ADDENDUM NUMBER 2

Friday, May 18, 2018

PROJECT:
FAIRHOPE CIVIC CENTER HVAC REPLACEMENT
FAIRHOPE, ALABAMA
GMC PROJECT NO. AMOB170024

GUARD RAIL DETAIL

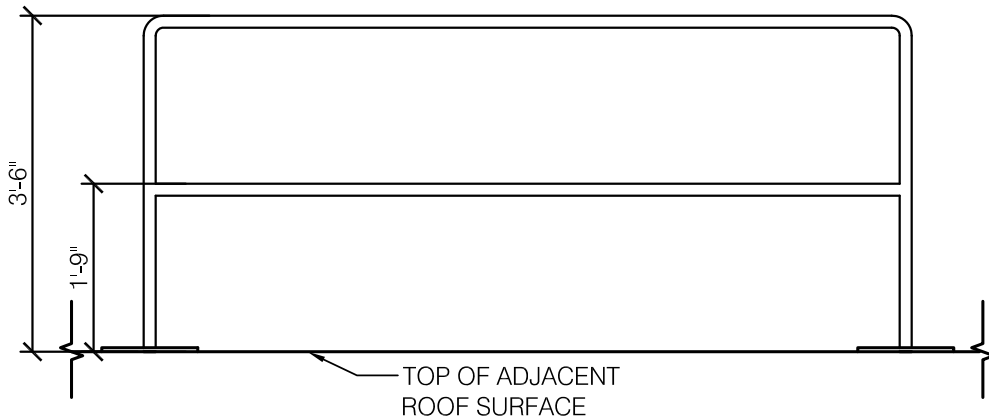
- D. Contractor shall use externally wrapped sheet metal for the supply and return air duct drops from the new RTU's, for the first 36" below the roof deck. Ensure all new duct is properly supported from the structure above. Contractor is responsible for relocating/rerouting any conduit and wiring located within the joist space that interferes with the routing of the new duct.
- E. As a clarification, the two new RTU's to be installed on these documents shall be positioned so that they are at minimum 10'-0" away from the edge of the roof.
- F. New guard rail system shall be provided at the roof edge for new RTU-4 (or New RTU-1 on mechanical) and/or equipment within 10 feet of roof edge. Please see attached Drawing ASD-01.

GUARDRAIL NOTES:

1. NEW GUARD RAIL SYSTEM SHALL EXTEND MINIMUM 30" BEYOND EXISTING HVAC EQUIPMENT
2. GUARD RAILS SHALL BE EQUAL TO "GARLOCK SAFETY SYSTEMS - RAILGAURD 200" NON-PENETRATING SAFETY GUARDRAIL SYSTEM- PROVIDE ALL BASE PLATES WITH PADS, LOCKING PINS, AND ACCESSORIES FOR A FULLY FUNCTIONING RAILING SYSTEM IN PLACE PER THE CONFIGURATIONS SHOWN ON THE PLANS.
